Product Change Notification / RMES-02XBET158

Notification Subject:

CCB 4407 Final Notice: Qualification of new lead frame design with Double ring Ag on die attach paddle (DAP) surface prep material for selected AT32UC3B0512, AT32UC3C2512C, AT32UC3C2128C, AT32UC3C2256C and AT32UC3C264C device families available in 64L TQFP (10x10x1mm) package using 295x295 mils lead frame paddle size at ANAP assembly site.

LeadFrame Comparison

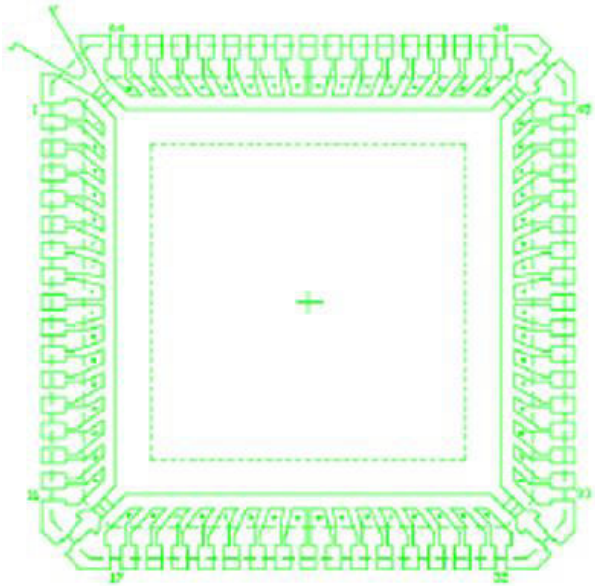
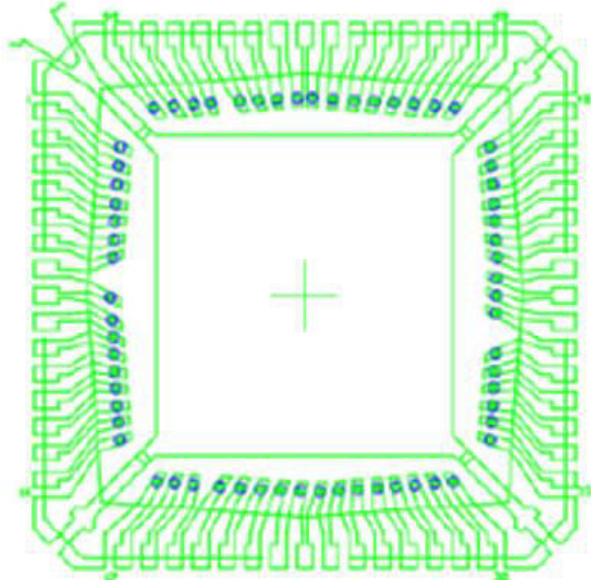
Lead frame material	C194	Lead frame material	C194
Lead frame Paddle size	295x295 mils	Lead frame Paddle size	224x240 mils
Lead frame die attach paddle (DAP) surface prep material	Double Ring Ag	Lead frame die attach paddle (DAP) surface prep material	Ring Ag
Lead frame material	C194	Lead frame material	C194
Lead frame Paddle size	295x295 mils	Lead frame Paddle size	295x295 mils
Lead frame die attach paddle (DAP) surface prep material	Double Ring Ag	Lead frame die attach paddle (DAP) surface prep material	Double Ring Ag
